Subject: Response to the Nuclear Regulatory Commission's ("NRC") notice of solicitation of public comments on risk-informed changes to loss-of-coolant accident technical requirements

**MARK EDWARD LEYSE'S RESPONSES TO THE NUCLEAR REGULATORY
COMMISSION'S NOTICE OF SOLICITATION OF PUBLIC COMMENTS ON
RISK-INFORMED CHANGES TO LOSS-OF-COOLANT ACCIDENT
TECHNICAL REQUIREMENTS**

Appendix A Photographs of the Assembly from FLECHT Run 9573

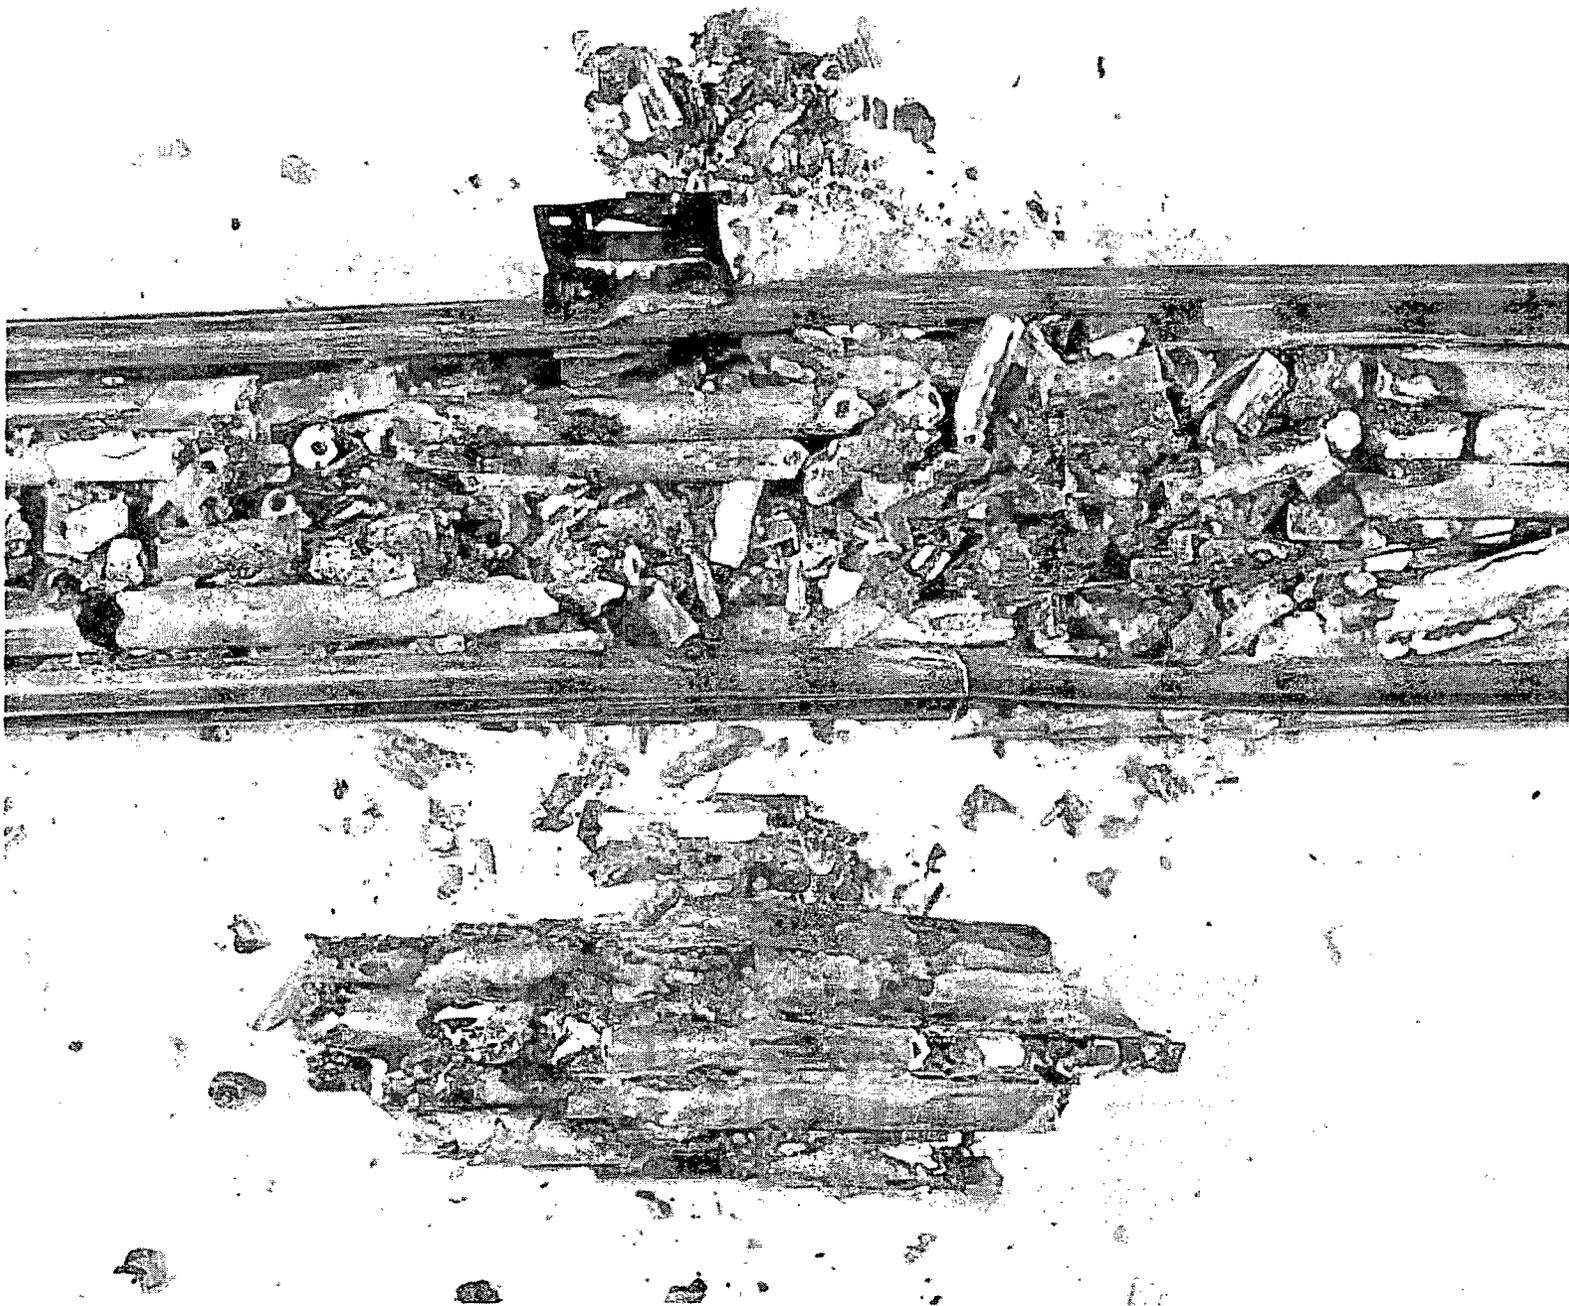
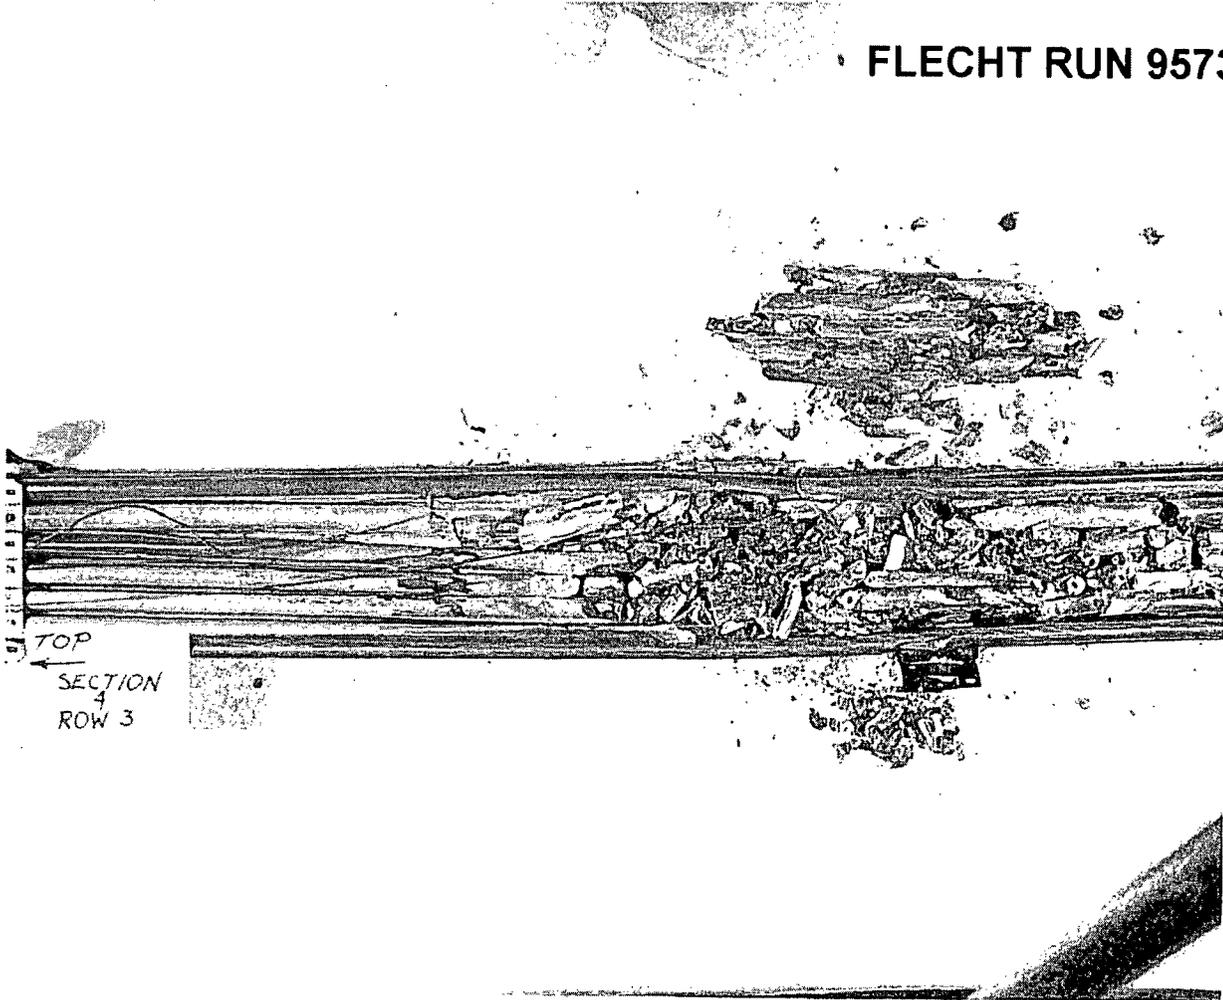
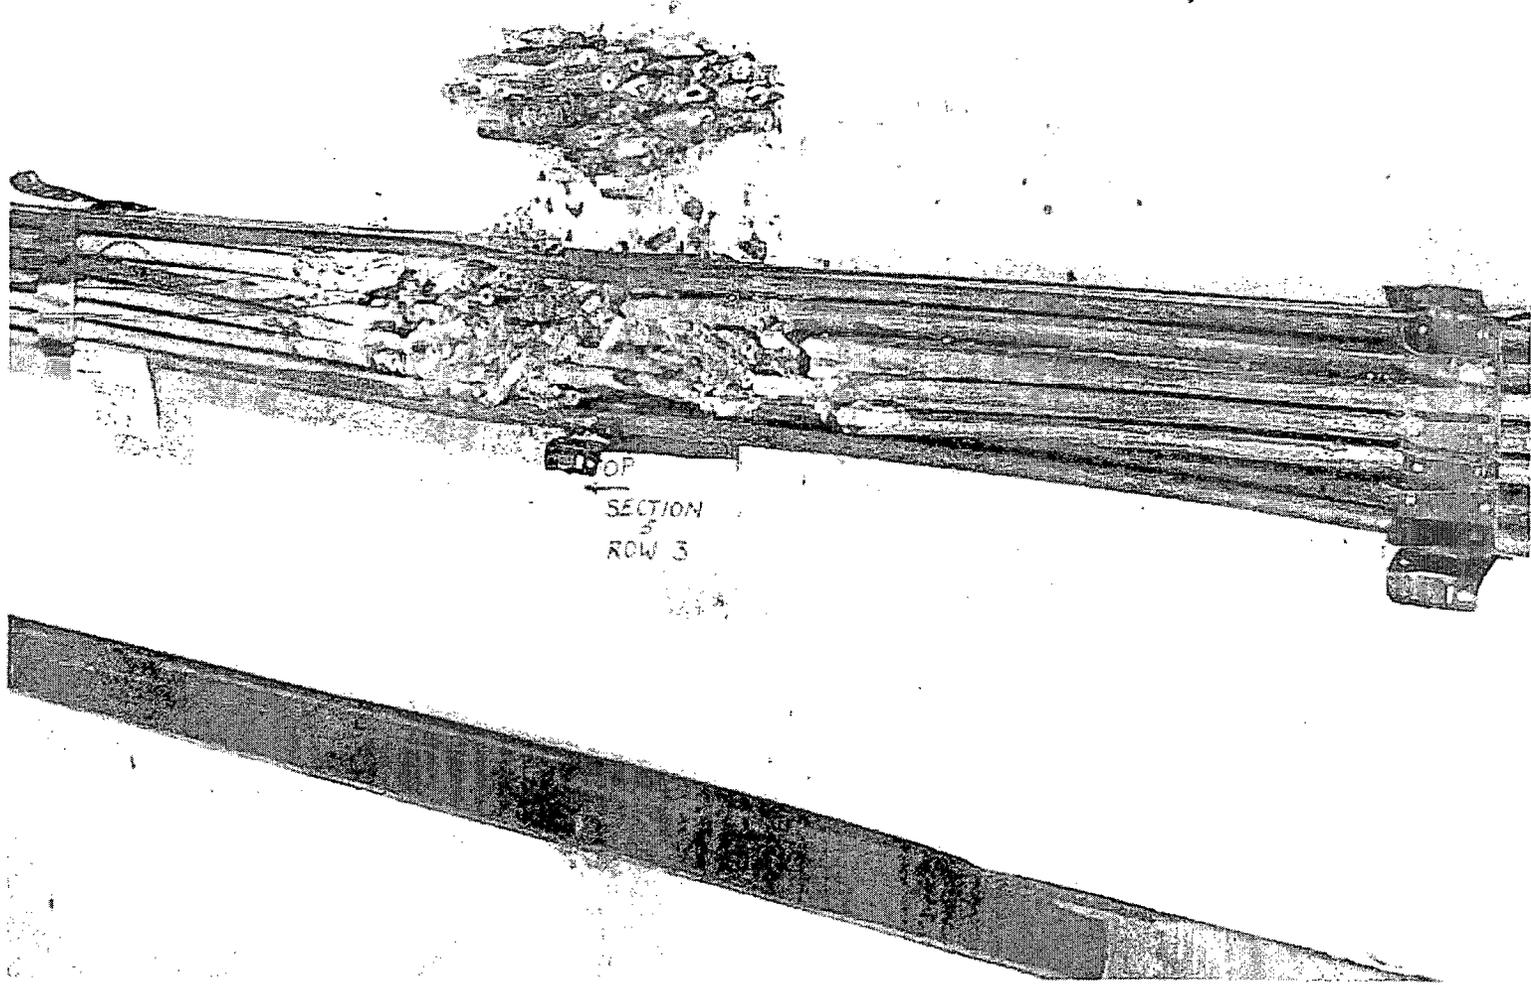
It is significant that within the first 18.2 seconds of FLECHT run 9573,¹¹³ “negative heat transfer coefficients were observed at the bundle midplane for 5...thermocouples;”¹¹⁴ *i.e.*, more heat was transferred into the bundle midplane than was removed from that location. In petition for rulemaking 50-76 (“PRM-50-76”), Robert H. Leyse, the principal engineer in charge of directing the Zircaloy FLECHT tests and one of the authors of “PWR FLECHT Final Report,” states that “[t]he negative heat transfer coefficients [occurring within the first 18.2 seconds of run 9573] were calculated as a result of a heat transfer condition during which more heat was being transferred into the heater than was being removed from the heater[; used in the FLECHT tests to simulate fuel rods]. And the reason for that condition was that the heat generated from Zircaloy-water reactions at the surface of the heater added significantly to the linear heat generation rate at the location of the midplane thermocouples.”¹¹⁵

At the time of the initial [heater element] failures, midplane clad temperatures were in the range of 2200-2300°F. The only prior indication of excessive temperatures was provided by the 7 ft steam probe, which exceeded 2500°F at 16 seconds (2 seconds prior to start of heater element failure).¹¹⁸

Therefore, it is reasonable to conclude that a superheated mixture of steam and hydrogen, and entrained water droplets, caused heating of Zircaloy cladding in the midplane location of the fuel rod. It is also reasonable to conclude that the “negative heat transfer coefficients [that] were observed at the bundle midplane for 5...thermocouples”¹¹⁹—the occurrence of more heat being transferred into the bundle midplane than was removed from that location—within the first 18.2 seconds of FLECHT run 9573, were caused by an exothermic zirconium-water reaction. Additionally, it is reasonable to conclude that “the impression left from [FLECHT] run 9573” cannot be separated from concerns about zirconium-water reaction models.

FIGURE 4.1. Typical Cladding Temperature Behavior

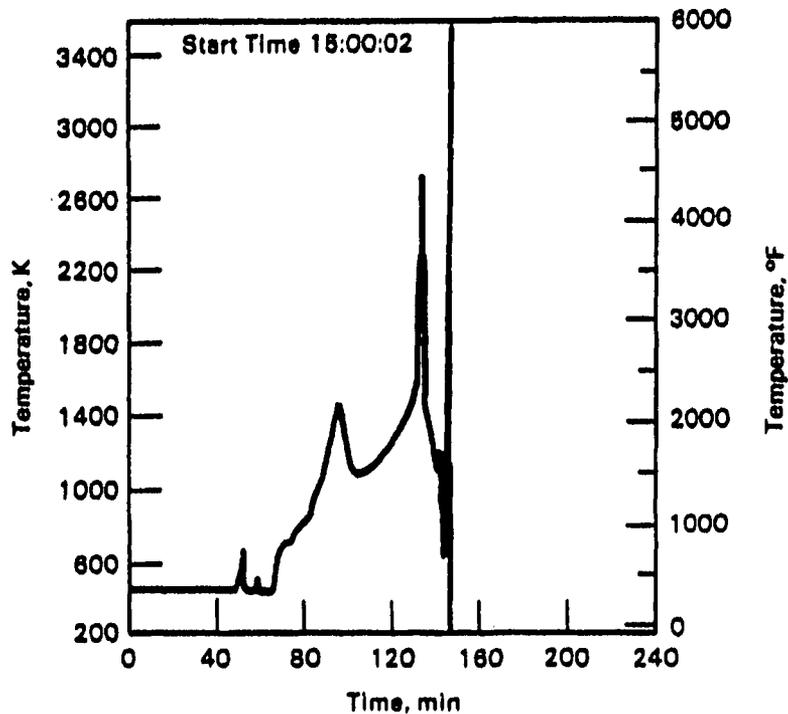
Furthermore, although the graphs of “Typical Cladding Temperature Behavior”²⁰⁰ and “Pseudo Sensor Readings for Fuel Peak Temperature Region”^{201, 202} are not large enough to clearly delineate what the temperature values were at given times during the FLHT-1 test, the graphs’ cladding-temperature values are consistent with the postulation that the temperature excursion began at a temperature far lower than 1700°K, at a temperature closer to 1520°K (see Appendix E Figure 4.1. Typical Cladding Temperature Behavior and Figure 5.4. Pseudo Sensor Readings for Fuel Peak Temperature Region). The slopes of the lines of the cladding-temperature value plots in the graphs become nearly vertical, when the cladding-temperature values reach approximately 1520°K, indicating the onset of the temperature excursion, at a rate of 10°K/sec. or greater.

Typical cladding temperature behavior at one position in the assembly during the test is shown in Figure 4.1. At about 60 to 70 min. along the abscissa, a temperature increase [commenced] when the [bundle coolant] flow rate was about 9 kg/hr. (20 lb/hr.). The [cladding] temperature increased until about 95 min. and [reached] 1450°K (2150°F), at which time the bundle coolant [flow] rate was increased to 18 kg/hr. (40 lb/hr.) to stabilize the temperature. However, the [cladding] temperature rapidly dropped to about 1060°K (1450°F). The bundle coolant flow rate was then decreased through a series of steps to a minimum of 9 kg/hr. (20 lb/hr.). This action stopped the temperature decrease and started another temperature rise. When the temperature reached about 1475°K (2200°F), the bundle coolant flow [rate] was again increased to stop the temperature ramp. This led to a stabilized condition. The flow was increased in steps

Figure 3.7 Comparison of two cladding temperatures at the 0.69-m (27-in.) elevation in Fuel Assembly 5.

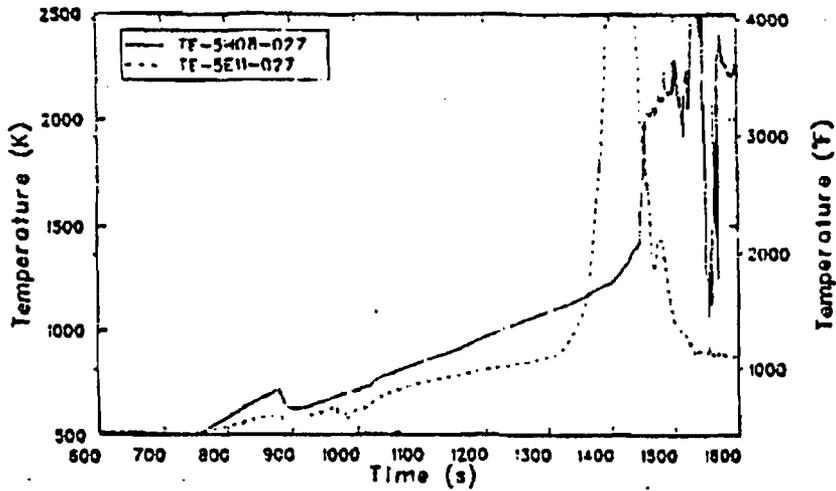
The first recorded and qualified rapid temperature rise associated with the rapid reaction between Zircaloy and water occurred at about 1430 [seconds] and 1400°K on a guide tube at the 0.69-m (27-in.) elevation. This temperature is shown in Figure 3.7. A cladding thermocouple at the same elevation (see Figure 3.7) reacted earlier, but was judged to have failed after 1310 [seconds], prior to the rapid temperature increase. Note that, due to the limited number of measured cladding temperature locations, the precise location of the initiation of [the] metal-water reaction on any given fuel rod or guide tube is not likely to coincide with the location of a thermocouple. Thus, the temperature rises are probably associated with precursory heating as the metal-water reaction propagates away from the initiation point. Care must be taken in determining the temperature at which the metal-water reaction initiates, since the precursory heating can occur at a much lower temperature. It can be concluded from examination of the recorded temperatures that the oxidation of Zircaloy by steam becomes rapid at temperatures in excess of 1400°K (2060°F).^{223, 224}

²²⁴ See Appendix F Figure 3.7. Comparison of Two Cladding Temperatures at the 0.69-m (27-in.) Elevation in Fuel Assembly 5 and Figure 3.10. Comparison of Two Cladding Temperatures at the 0.69-m (27-in.) Elevation in Fuel Assembly 5 with Saturation Temperature.

Fig.1 :
Sensitivity calculation on the B9R test. Temperature escalation at the hot level (0.6 m) with different Contact Area Factors (CAF)

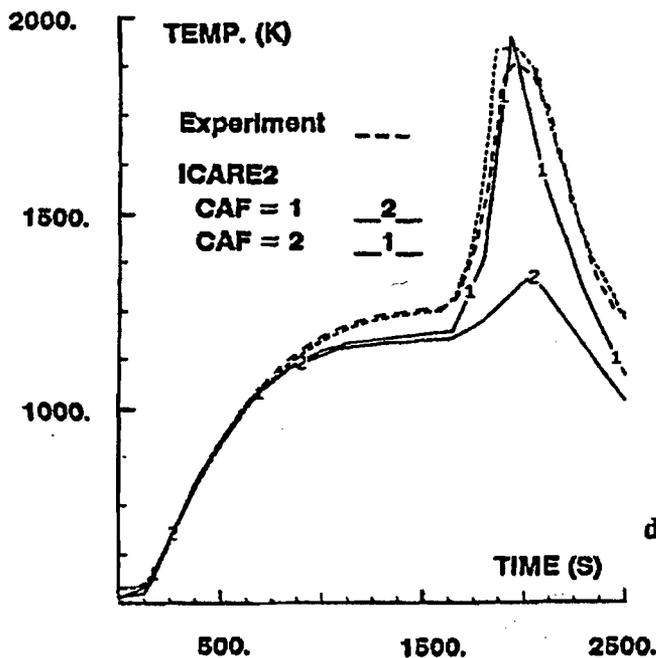
Neither paper states what peak cladding temperatures were at the outset of the autocatalytic oxidation reaction; however, a graph of the cladding-temperature values at the 0.6 meter "hot-level" indicates that the autocatalytic oxidation reaction began when cladding temperatures were below 1477°K (2200°F)²⁵⁸ (see Appendix G Figure 1. Sensitivity Calculation on the B9R Test: Temperature Escalation at the Hot Level (0.6 m) with Different Contact Area Factors (CAF)).

FIGURE 2.1: TEMPERATURE REGIMES FOR EXTENSIVE LIQUID PHASE FORMATION AND RELOCATION

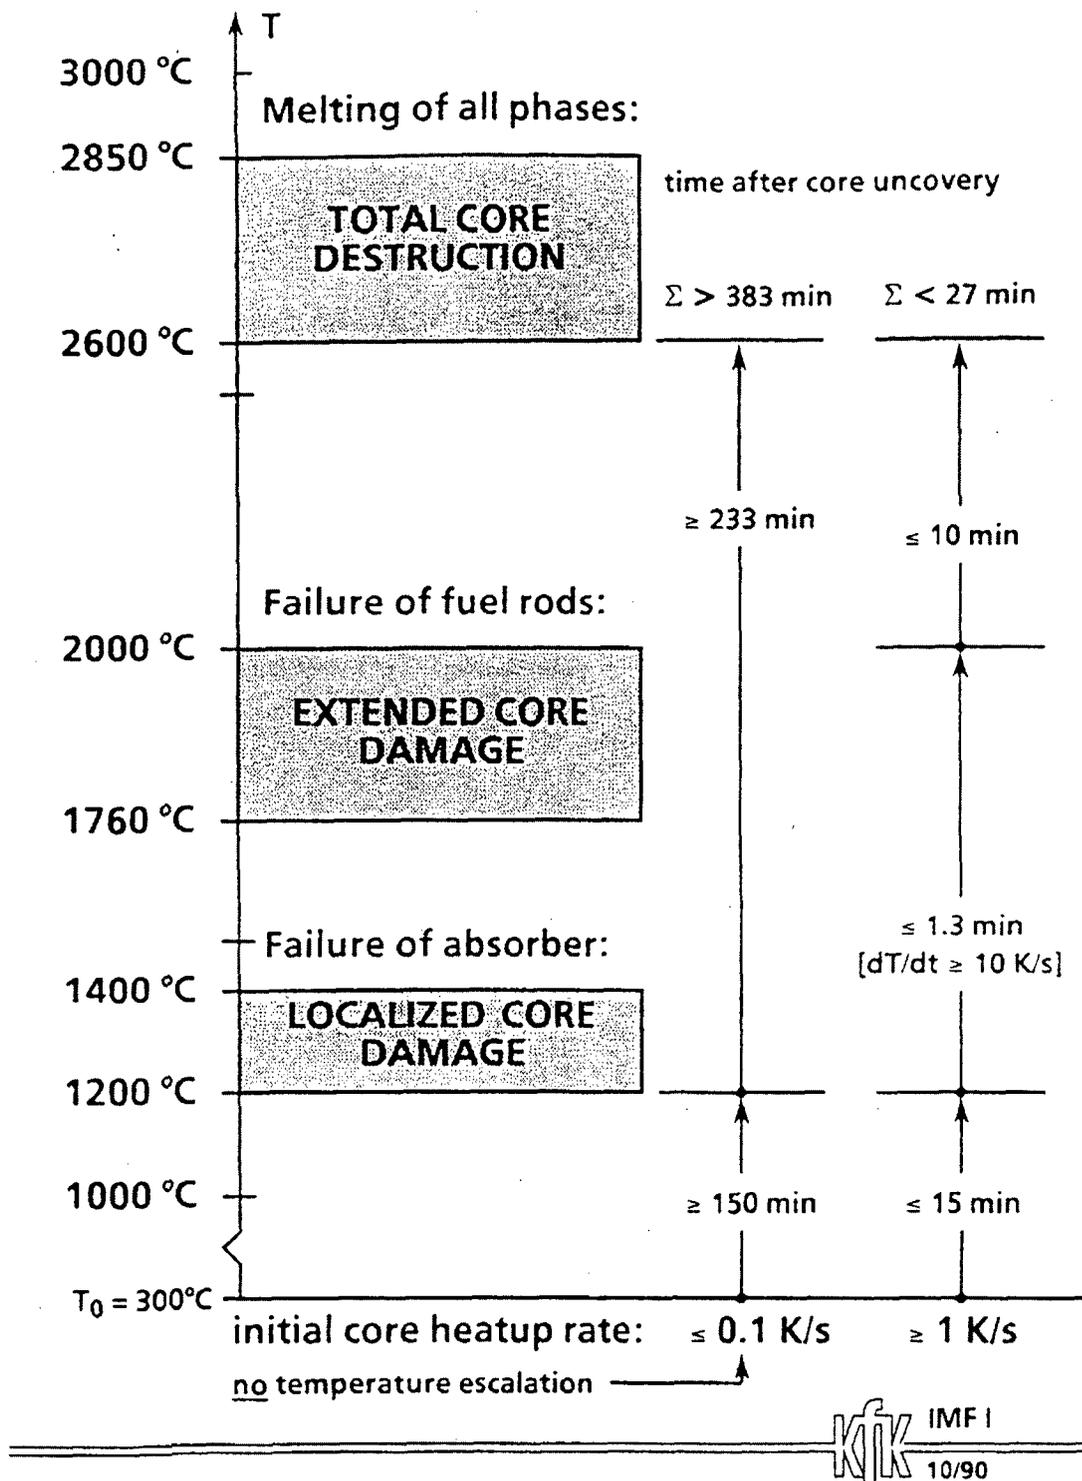
³¹³ See Appendix H Figure 2.1. Temperature Regimes for Extensive Liquid Phase Formation and Relocation, which depicts that the onset of temperature escalations of 10°K/s or greater occur when cladding temperatures reach 1200°C (2192°F).
